Office Action Summary	Application No. 10/587,153	Applicant(s) ARTELSMAIR ET AL.	
	Examiner KET DANG	Art Unit 4118

DETAILED ACTION

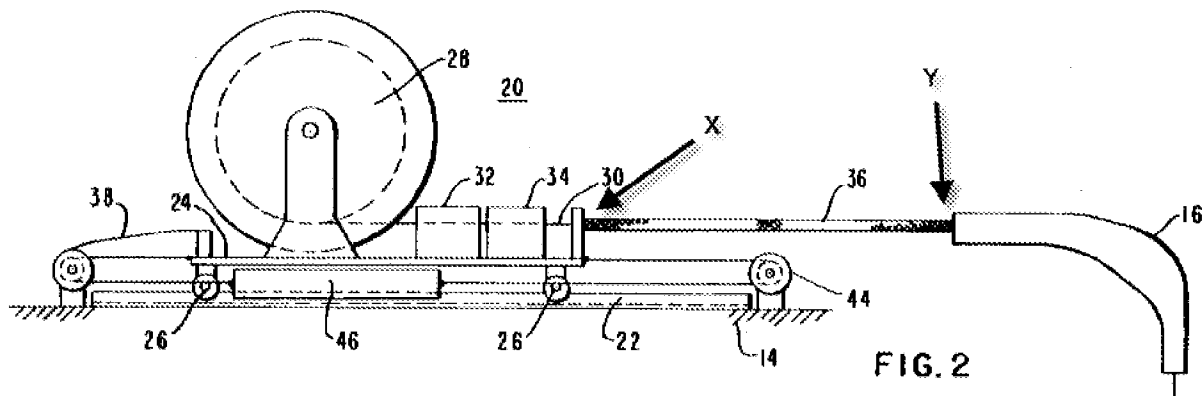
the housing 36 (Fig. 2), wherein one end of the wire core 30 (Fig. 2) is fixed in an end region of the housing Y (Fig. 2 below).

and a measuring means 34 (Fig. 2) is provided to detect the deflection of the wire core 30 (Fig. 2), wherein the wire core is displaceable mounted in a guide element 24 (Fig. 3) on the opposite end region; and two coupling mechanisms X/Y (Fig. 2 above) for connection with a wire guide hose for the wire core 30 (Fig. 2) are arranged on the housing 36 (Fig. 2).
